CHIQUITA CANYON, LLC [FACILITY ID No. 119219] – EXHIBIT E TO DECLARATION OF CRAIG H. BENSON, PHD, PE, BCGE,
BCEE, NAE

January 13, 2026

RE: Notice of Deficiency and Clarification of EPA's Position Regarding Extension of Covered Area of the Chiquita Canyon Landfill

Figure 1. Reaction Settlement Area at the Chiquita Canyon Landfill. The red area was estimated using one foot or more settlement between June 19, 2023, and July 21, 2023.

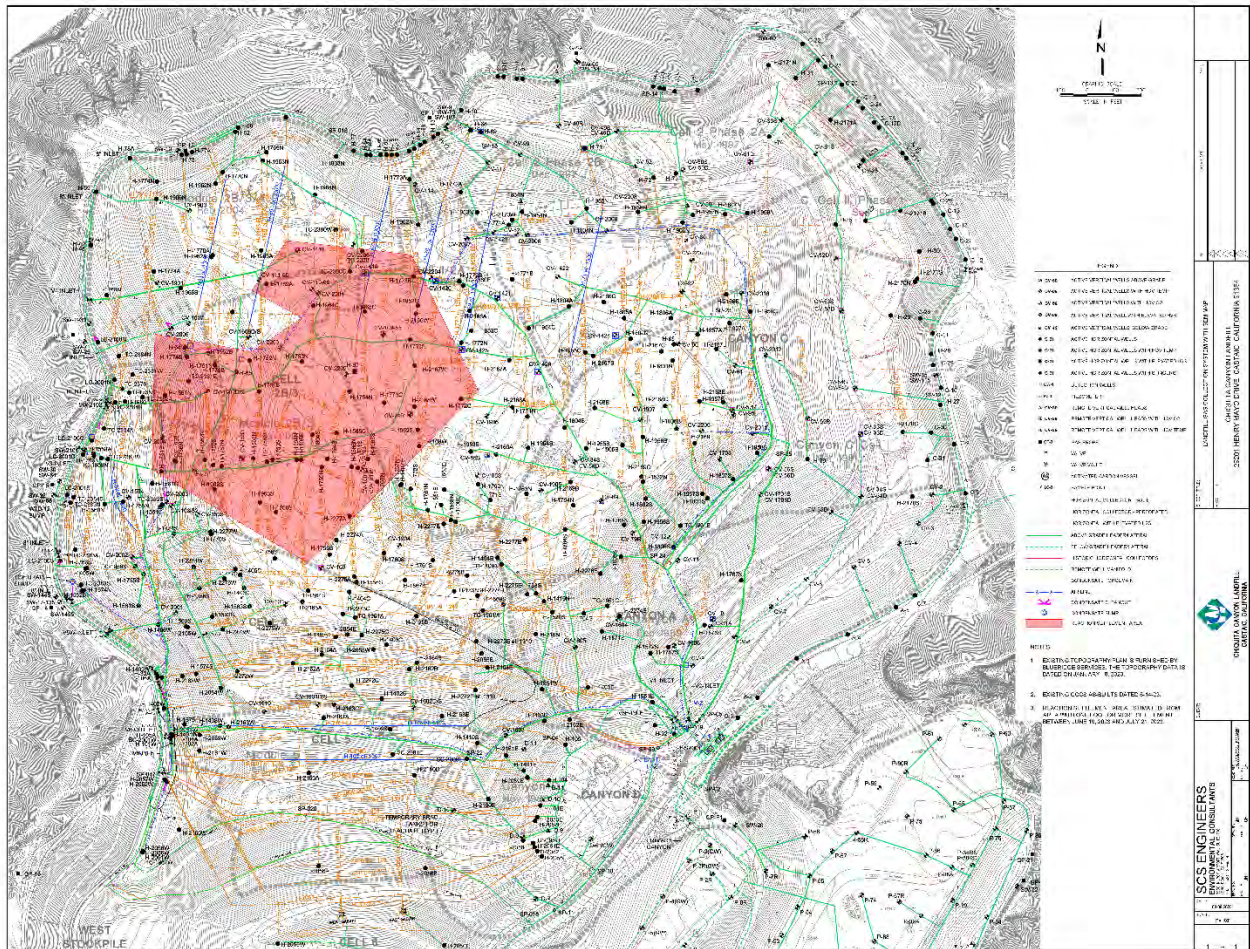
Possibly to account for where the odors are most likely being generated, the CCL used areas that settled one foot or more between June 19, 2023, and July 21, 2023. Figure 1 shows the reaction settlement area at the CCL.

Figure 6. Gas Wellheads exceeding temperatures over 170°F and CO over 1,500 ppmv at the Chiquita Canyon Landfill, July 2023.

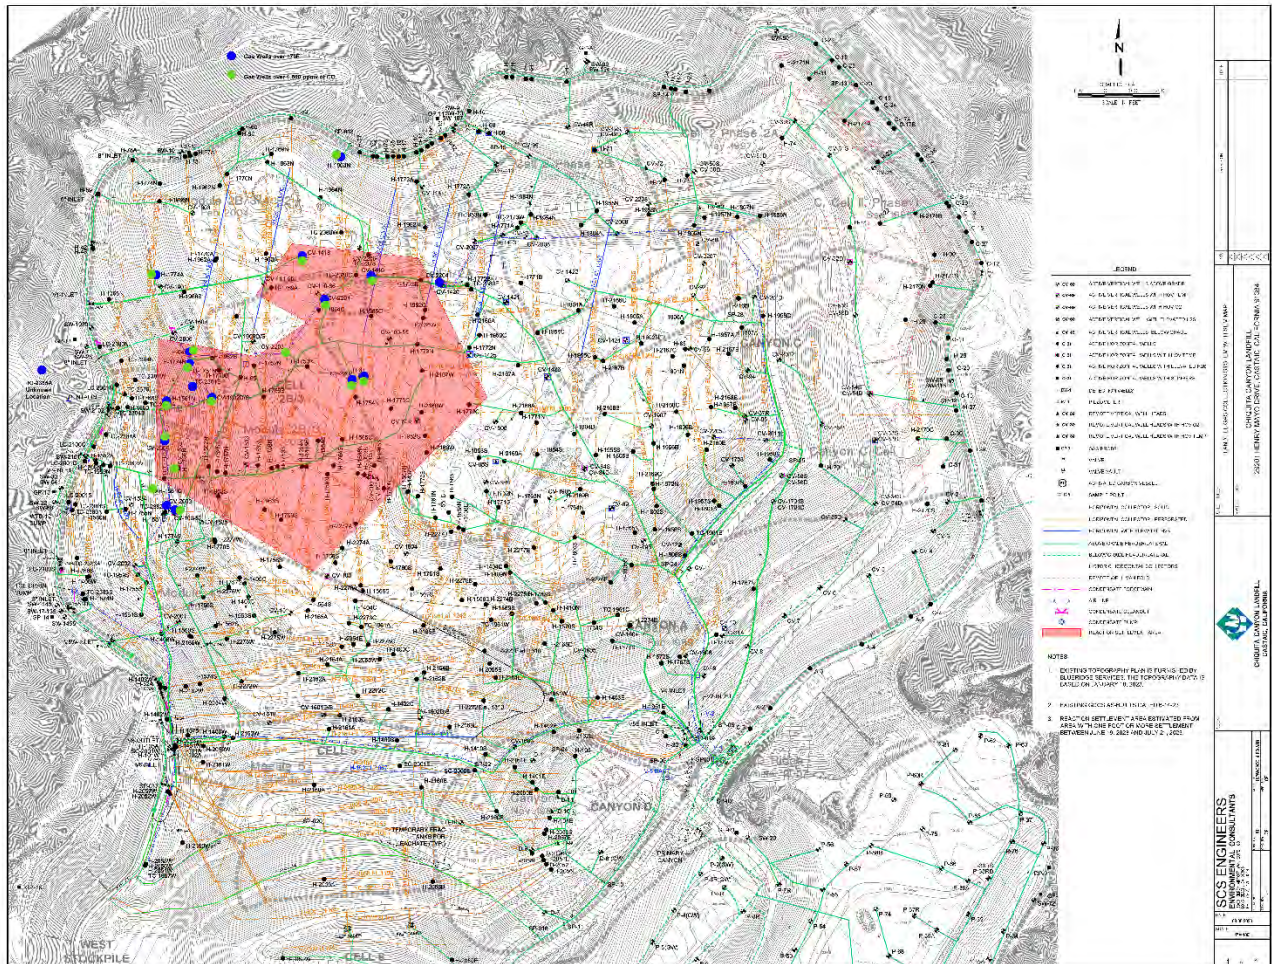
July 2023 is shown in Figure 6. Wells with CO above 1,500 ppm (indicated by a green circle) and temperatures over 170°F (indicated by a blue circle) were plotted on the CCL's Reaction Settlement Area Map. Circles that share a boundary indicate the well has high CO and temperature.

Figure 1. The reaction settlement area at the Chiquita Canyon Landfill. Red indicates one foot or more settlement between June 19, 2023, and July 21, 2023.

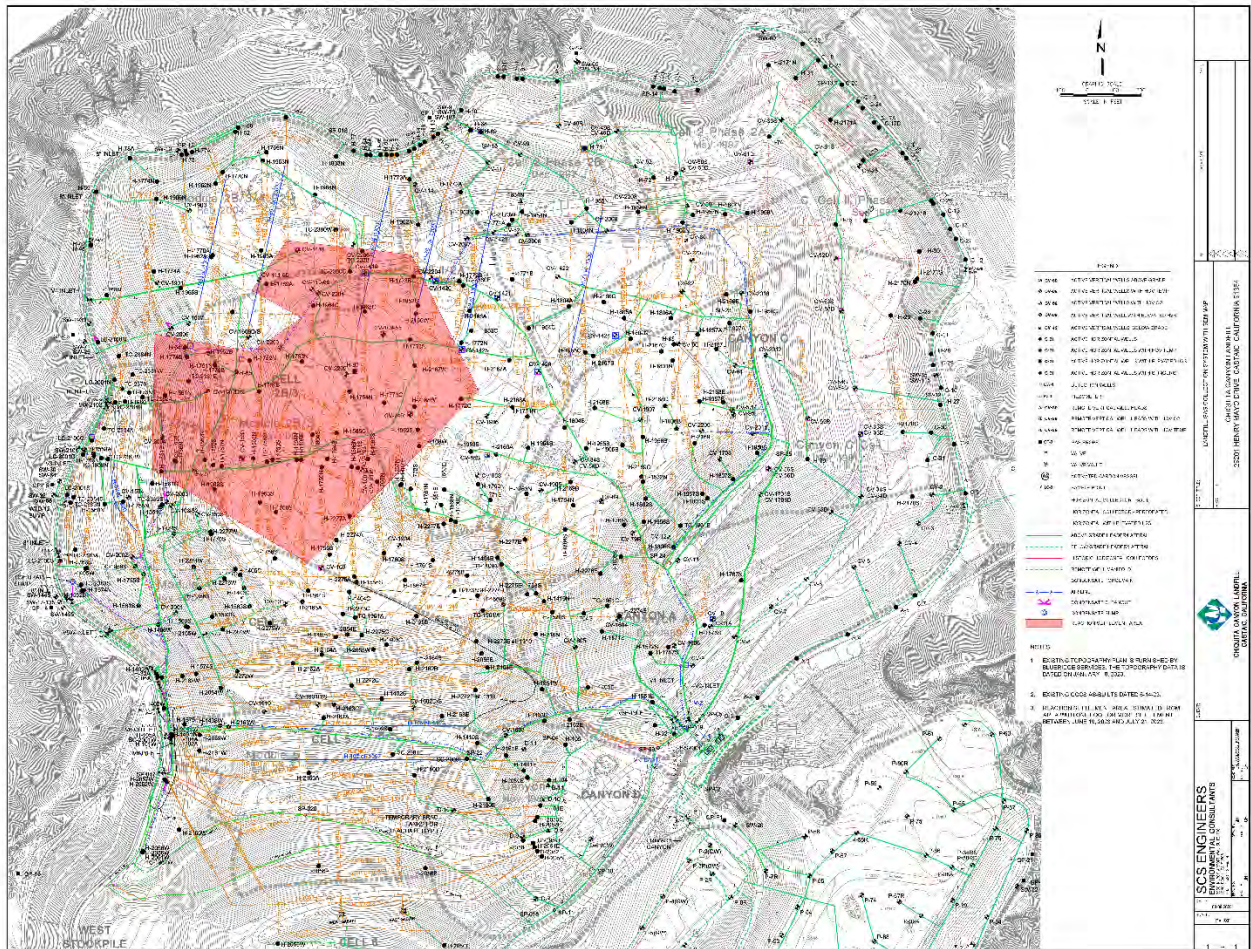
The two CCL reaction site maps from July 2023 and September 2023 show that the incident has expanded in all directions, most notably to the north and west. The approximate size of the incident now is between 30 and 35 acres.

Figure 1. Current Reaction Area Under the Geomembrane Area as of September 5, 2024.

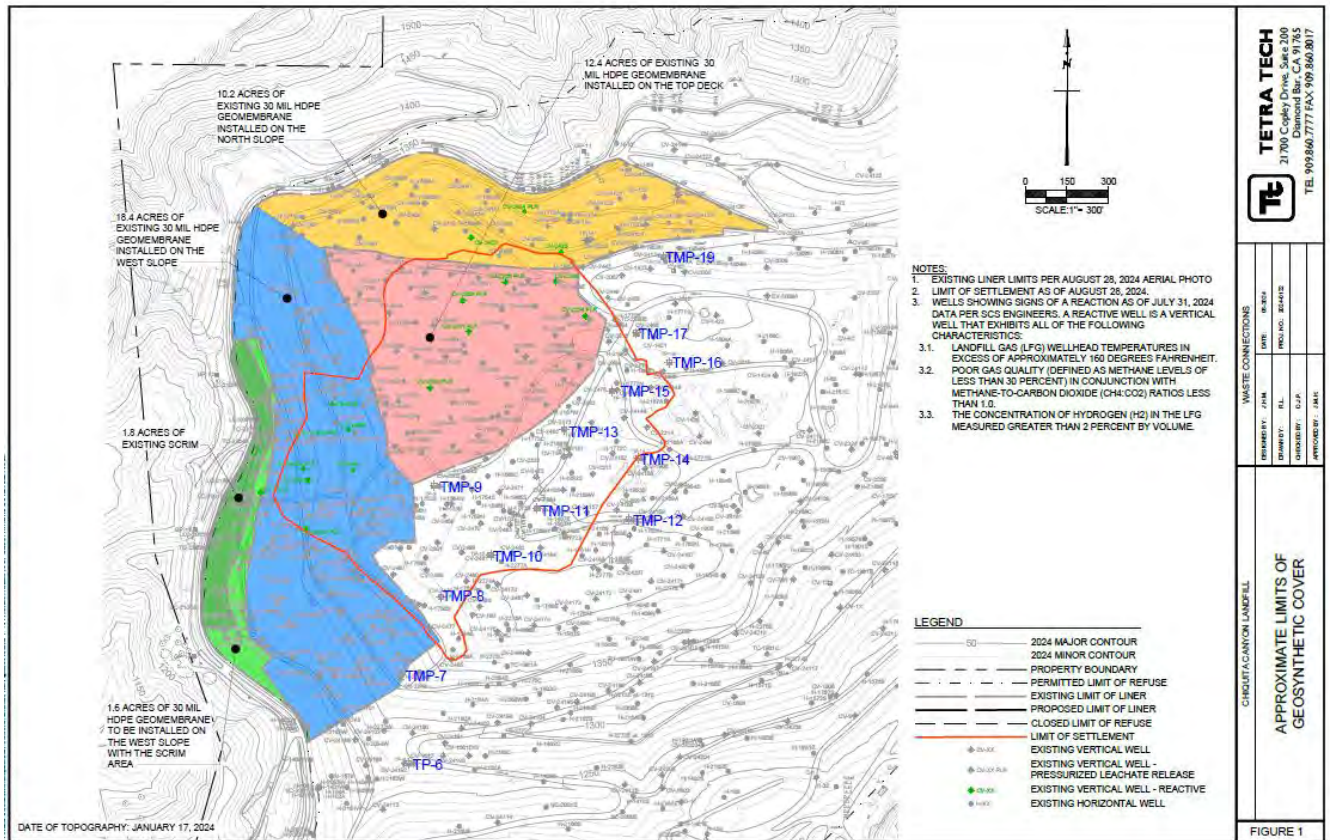
The main waste area, which contains the 40-acre reaction area, consists of cells 1 and 2, modules 1 to 5, and canyons A to D. Figure 1 identifies the current area covered by the geomembrane as of September 5, 2024.

Figure 2. TMP-14 Temperature Profile Demonstrating a Shallow SET Event Developing at Chiquita Canyon, April 24, 2024, to March 19, 2025. (Source: SCS Engineers TMP Data)

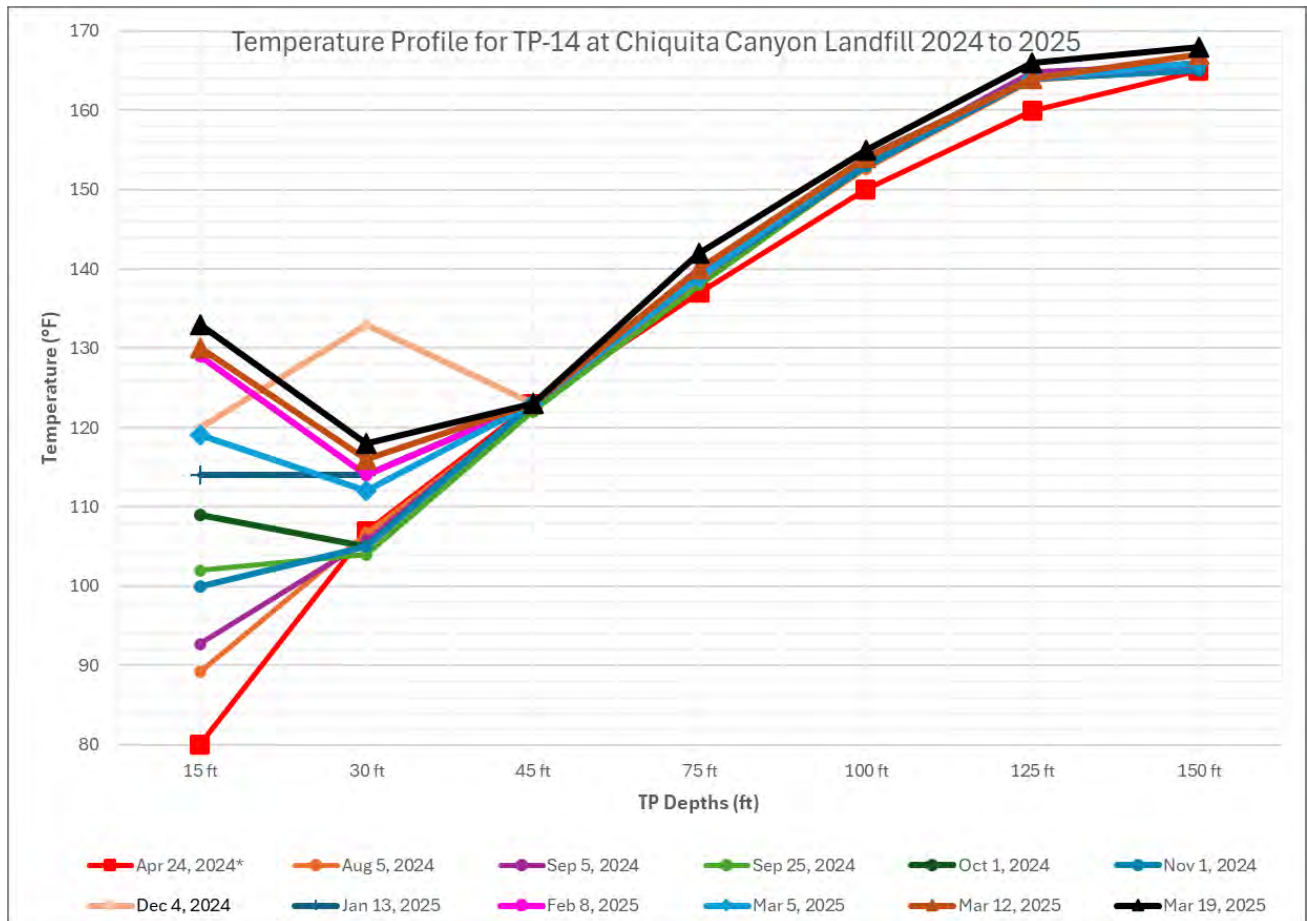
As an example of how wellhead temperatures can mask what is occurring in the waste, as shown in **Figure 2**, TMP-14 reported a temperature of 80°F (26.7 °C) on April 24, 2024, at the fifteen-foot probe. By March 19, 2025, the temperature at the 15-foot probe had increased to 133°F (56°C). This shallow temperature spike was not observed in gas well CV-1906, approximately 10 to 15 feet away, where the wellhead temperature was reported to be 68°F (20°C) on April 1, 2024, and 60°F (15.5°C) on March 19, 2025. There were also significant temperature swings in the wellhead temperature data for gas well CV-1906, where the temperature rose from 95°F (35°C) to 121°F (49°C) and then dropped to 73°F (22.7°C) within a month. However, all the wellhead temperatures are below the regulatory threshold and do not require further analysis. Data from TMP-14 indicated that on March 19, 2025, the temperature reached 133°F (56°C) and exceeded the 131°F (55 °C) threshold. CV-1906 is also experiencing a significant oxygen overdraw at this location. The percent oxygen has varied from 10.9 percent on March 4, 2024, to 18.7 percent on March 6, 2025. The average oxygen for the past year at this well is 8.4 percent. Continued high oxygen levels above 2 percent and temperature spikes will lead to a SET Event. This TMP and gas well are approximately 450 feet away from the CCL-defined reaction boundary and CalRecycle staff do not believe the shallow temperature increases are connected to the main reaction area. CalRecycle believes that the temperatures of 166 to 168°F (74.4 to 75.5°C) at the deeper probe (i.e., 125 to 150 ft) are connected. However, this data demonstrates that the operation of the GCCS must not sacrifice LFG operational objectives/standard operating procedures (i.e., limiting oxygen to 2 percent¹⁵) to control emissions and risk developing of new SET Events. **Table 2** and **Table 3** provide the LFG data and temperatures for gas well CV-1906 and TMP-14.

Figure 8. Fissure and Crack Monitoring Report for February 2025. (Source: Geo-Logic Associates)

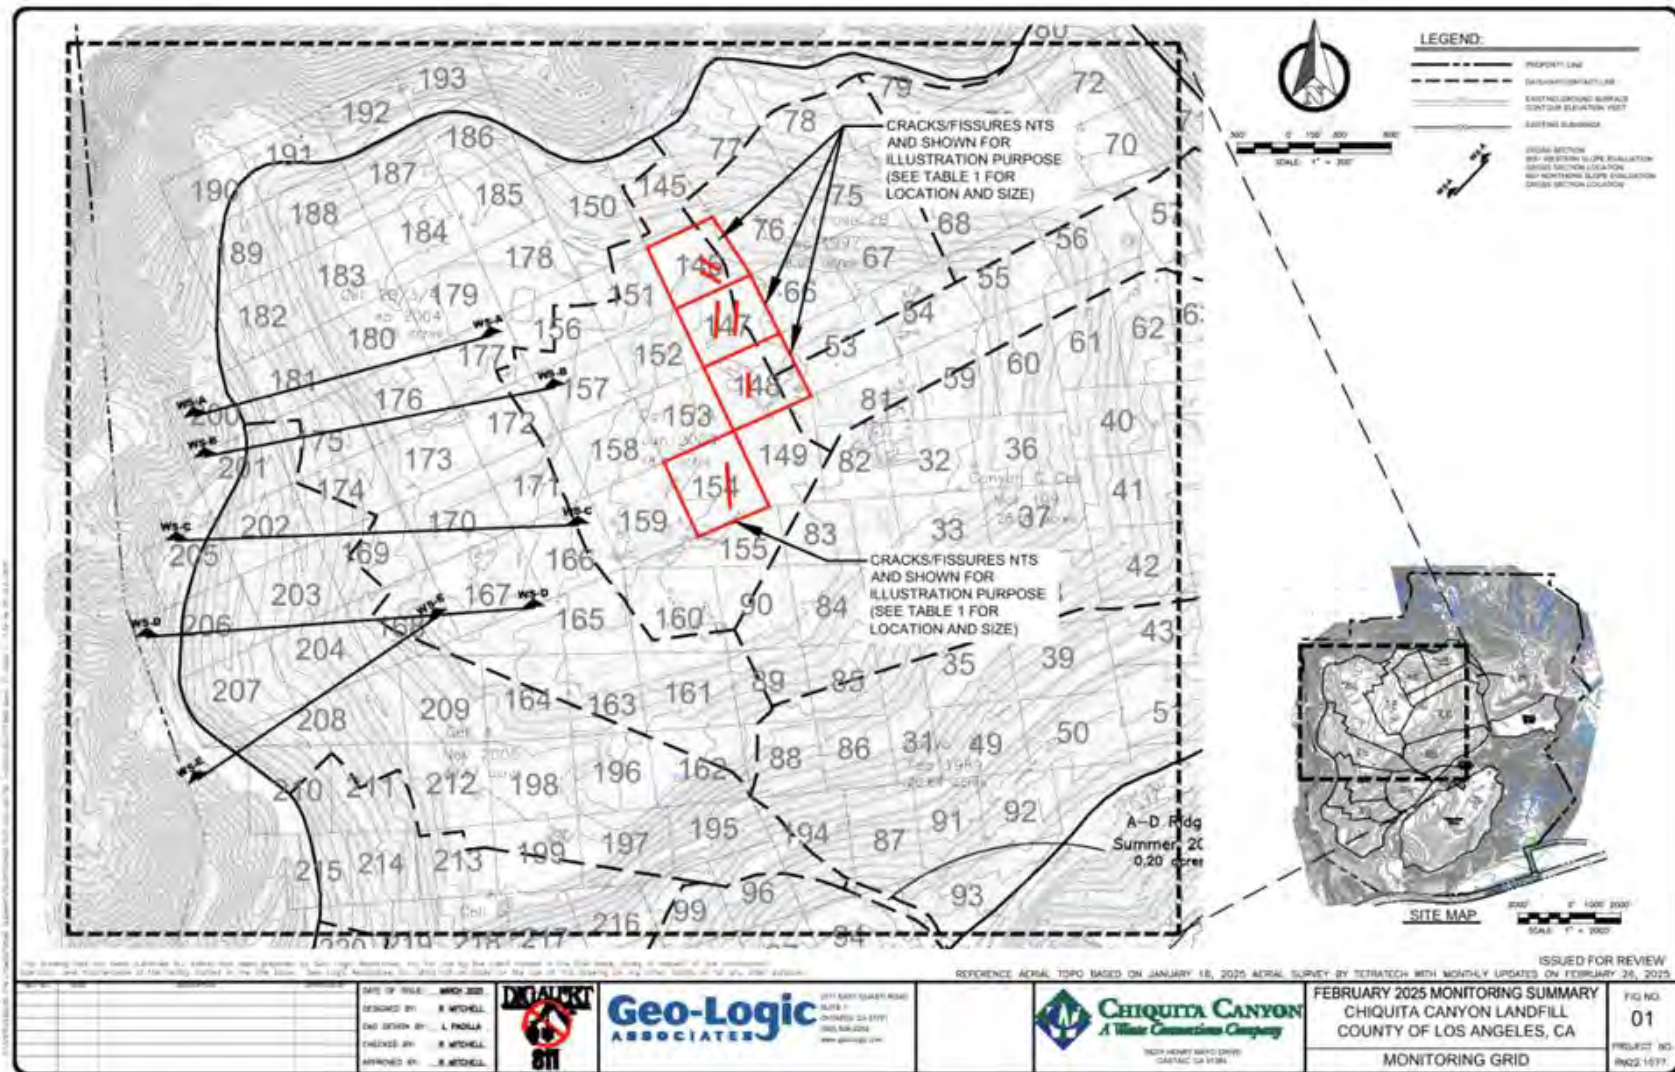
The CCL Settlement and Fissure Reports also align with the TMP temperature spikes data in grids. CCL's consultant, Geo-Logic Associates, provided a summary map of the recently occurring fissures in February 2025 (see **Figure 8**). Significant fissures and areas where the soil collapsed were documented in Grids 146, 147, 148, and 154. CalRecycle also reviewed FLIR data from October 2024; however, CCL has refused to provide the temperature layer on each photo. All data should be available.
